Bulletin No.: PI1341

Subject: Cooled Seat Fan Making Tapping Noise When in Use

Models: 2014-2015 Chevrolet Impala (VIN 1)

4002473

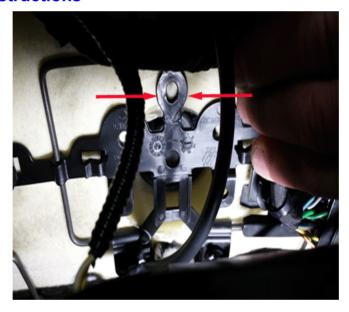
Some customers may comment on a tapping noise heard when using cooled seats.

This condition may be due to the seat cushion heat harness coming in contact with the cooling fan.

Re-route the seat cushion heat harness under the flex mat away from the cooling fan and attach a harness clip to the new location under the seat as shown above.
